WPR23LA004

Group Chair's Factual Report - Attachment 2
Bell Alert Service Bulletin No. 206L-20-184

206L-20-184

SUBJECT: SEGMENTED TAIL ROTOR DRIVESHAFTS 206-040-369-001/-101, 206-040-365-001/-117/-125 WITH BONDED ADAPTERS, PROOF LOAD TEST OF.

Figure 1 – Example of Tail Rotor Driveshaft Numbering and Index Marking

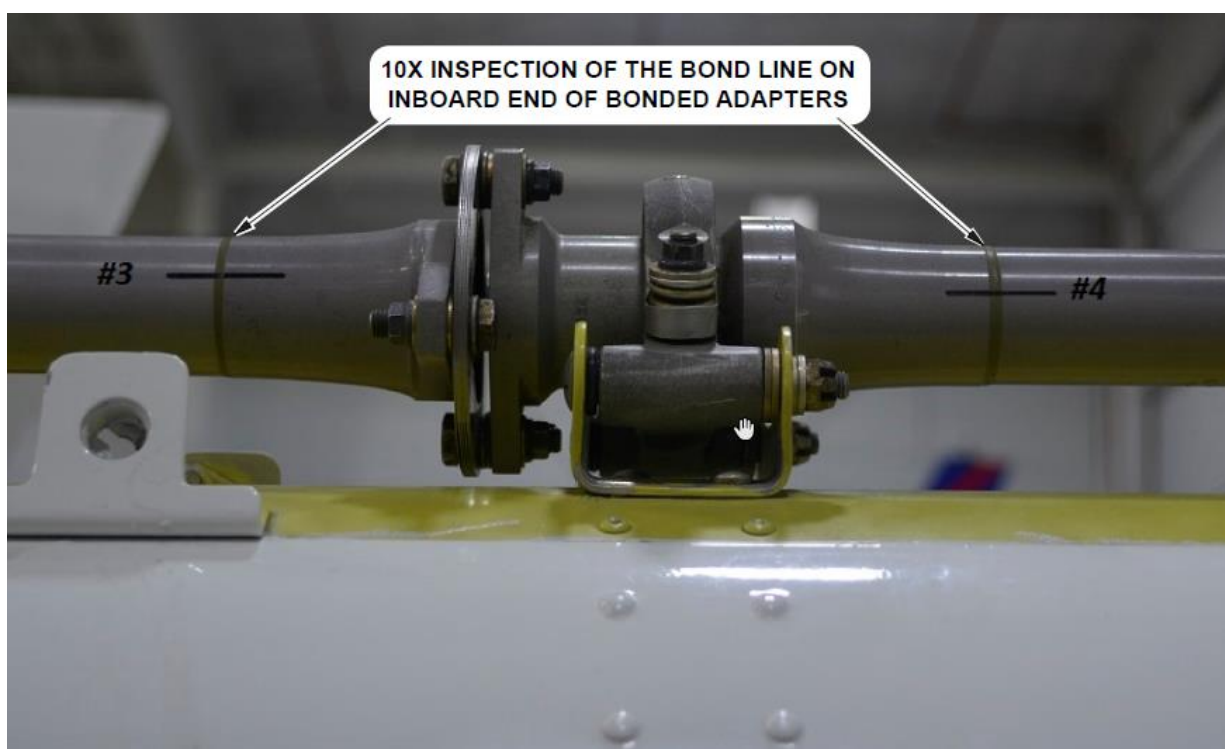
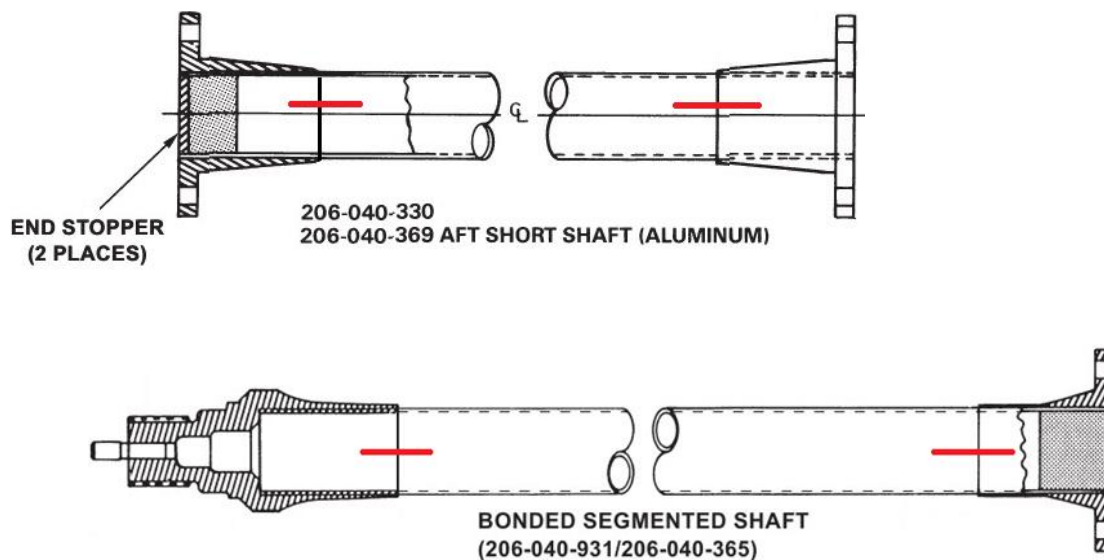
Revision A allows failed bonded tail rotor driveshafts to be replaced with serviceable bonded driveshafts that meet the intent of this bulletin and makes corrections to some of the metric dimensions in Figure 1 of this bulletin. **Revision B** introduces a new work aid to hold the forward end of the sliding adapter 206-040-373 used with the forward short shaft 406-040-315-111. The new work aid is not procurable and is to be locally manufactured (Figure 3). **Revision C** corrects the part numbers in Step 11 of the Accomplishment Instructions.

3. Carry out a detailed visual inspection of the bond line on the inboard end of the flange of the bonded tail rotor driveshafts using a 10X magnifying glass (Figure 1). If the bond line area shows damage such as cracked or missing adhesive or evidence of corrosion, the affected shaft is deemed un-repairable and must be removed from service and scrapped. Replace affected driveshaft(s) with a riveted tail rotor driveshaft(s) (TB 206L-02-207).

4. Index-mark each bonded tail rotor driveshaft and adapters with a fine tip felt marker (Figure 1) and number the shafts (example: Aft SS, 1, 2, 3, 4 and, 5. Driveshaft #5 being the closest to the tail rotor gearbox).

Figure 2 – Bonded Shaft Tool (206-244-001-101)
(May be ordered or locally manufactured)

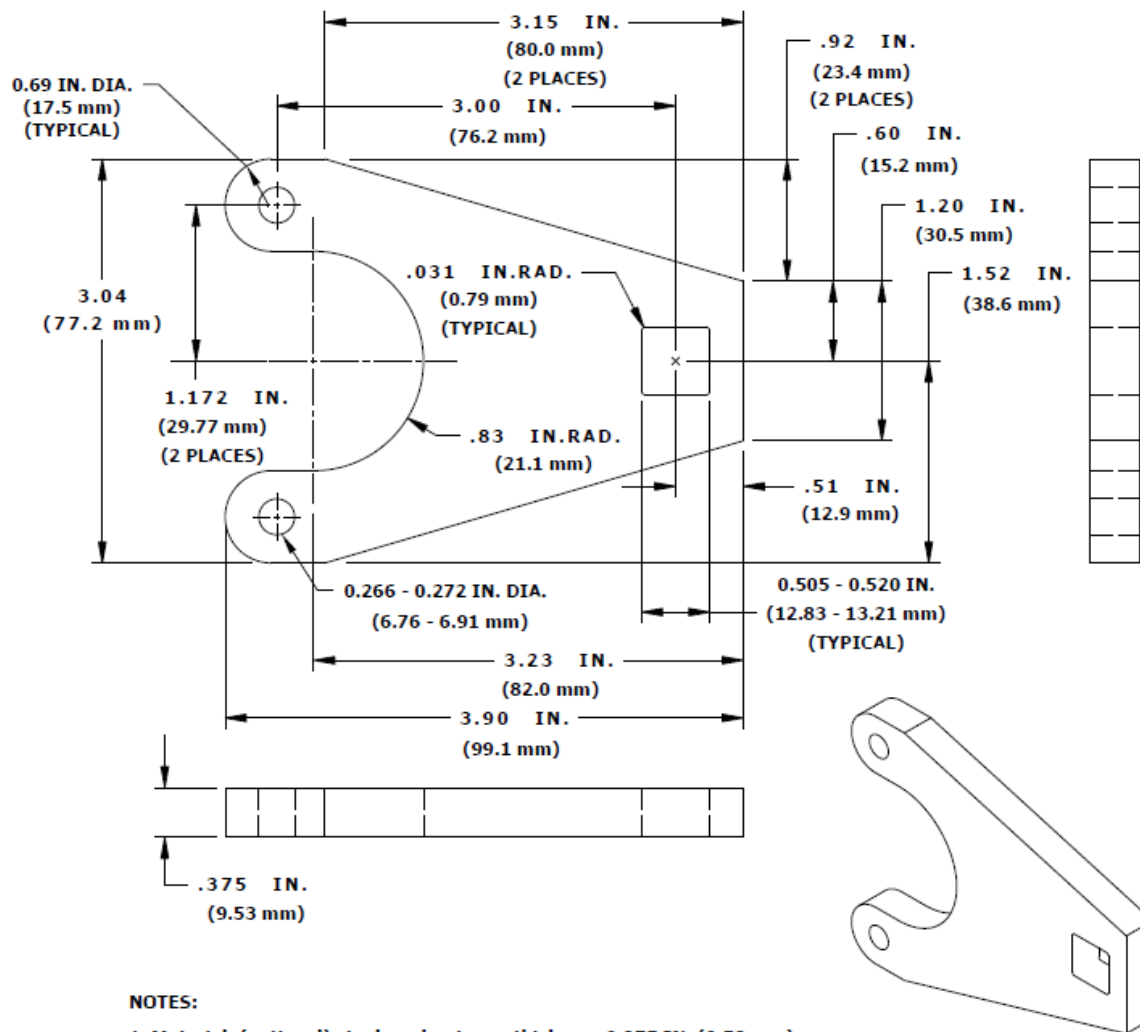
The bonded shaft tool part number 206-244-001-101 (QTY 2 required) can be procured through your Bell Supply Center or locally manufactured (Figure 2).

If the forward short shaft is removed, install the (206-040-328) sliding adapter and work aid (Bonded Shaft Tool 206-244-001-101) on the forward splines of the oil cooler fan shaft. The bonded shaft tool 206-244-001-101 can be locally manufactured using the information in Figure 2 or can be purchased from a Bell Supply Center.

Figure 4 – Bonded Shaft Work Aid Installation

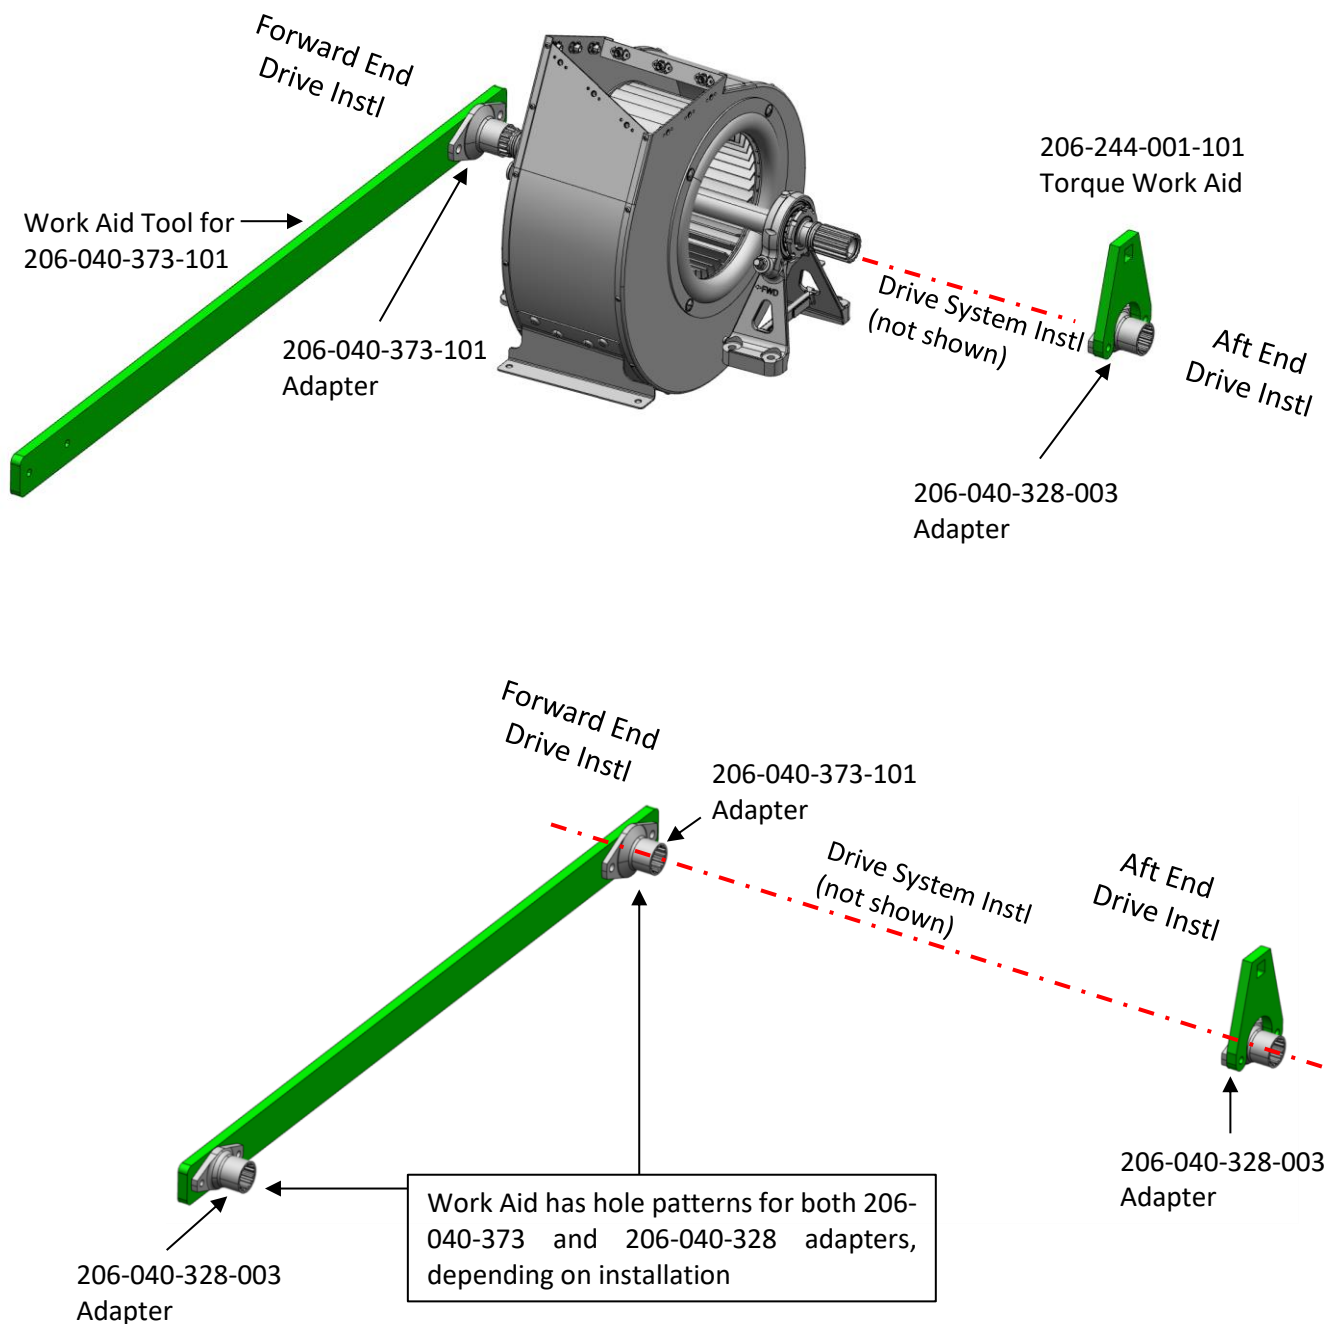
- a. Remove forward short shaft 406-040-315-111 (applicable Maintenance Manual).
 - b. Attach the 206-040-373 / 206-040-328 sliding adapter work aid on the forward face of the fan shaft sliding adapter (206-040-373) using two (2) AN175-12 or NAS6605-12 bolts, washers AN960-516L, and MS35650-3312 nuts, or equivalent (Figure 4).

- a. If the forward short shaft (206-040-325) has been removed, install the bonded shaft tool 206-244-001-101, or the 206-040-373 / 206-040-328 sliding adapter work aid, on the forward face of the sliding adapter (206-040-328) on the forward splines of the oil cooler blower shaft using two (2) AN174-12 or NAS6604-12 bolts, current washers AN960-416L, and nuts MS21042L4, NAS9926-4L or a MS35650-3252 nut, or equivalent (Figure 4 or 5).

Figure 5 - Examples of Bonded Shaft Tool Installations

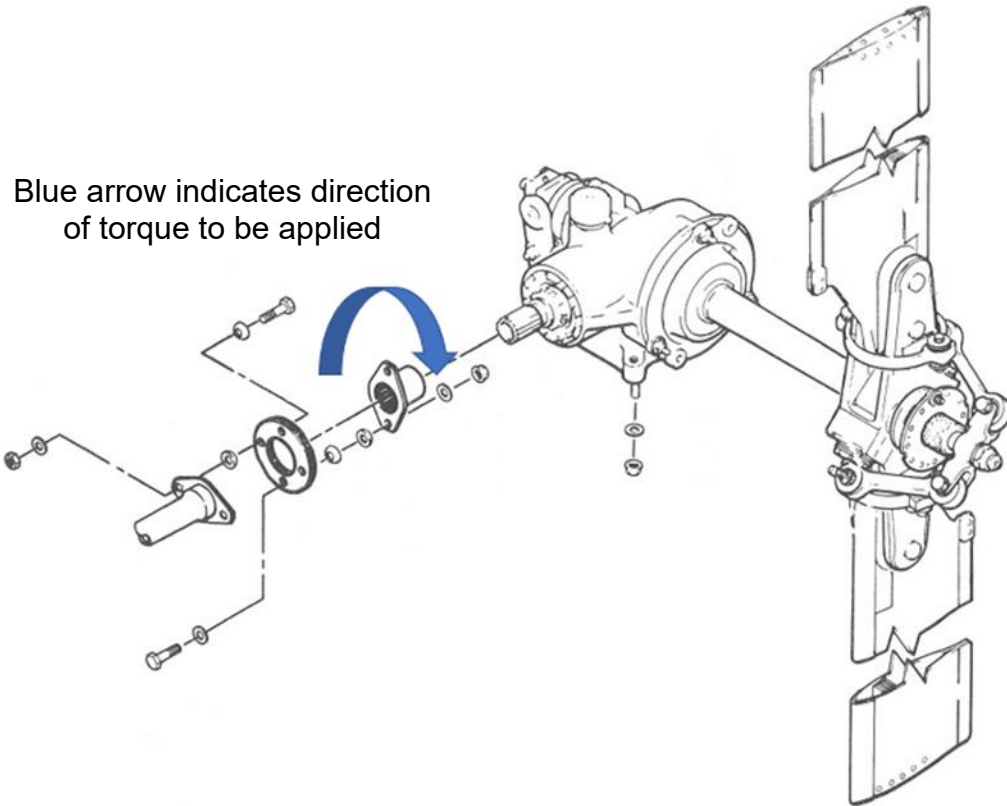
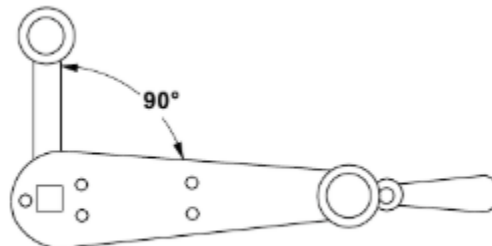
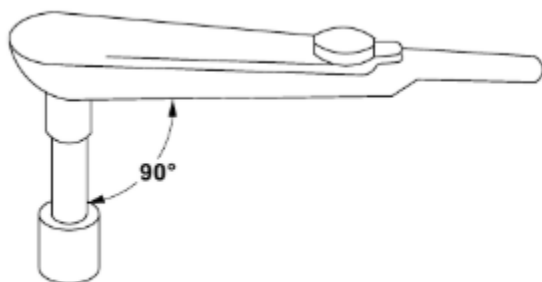
8. Install the second bonded shaft tool on the aft face of the sliding adapter (206-040-328) of the input pinion of the tail rotor gearbox using two (2) AN174-12 of NAS6604-12 bolts, current washers AN960-416L, and nuts MS21042L4, NAS9926-4L or a MS35650-3252 nut, or equivalent (Figure 5).

Figure 6 – Proof Load Testing

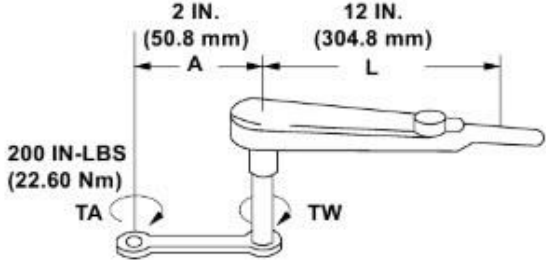
9. One person is required to hold the bonded shaft tool 206-244-001-101 with a ½-inch square drive breaker bar, or the 206-040-373 / 206-040-328 sliding adapter work aid, on the splines of the forward end of the oil cooler blower shaft (Figure 6).

10. One person is required to hold the torque wrench on the bonded shaft tool installed on the sliding adapter (206-040-328) of the tail rotor gearbox input pinion (Figure 6).
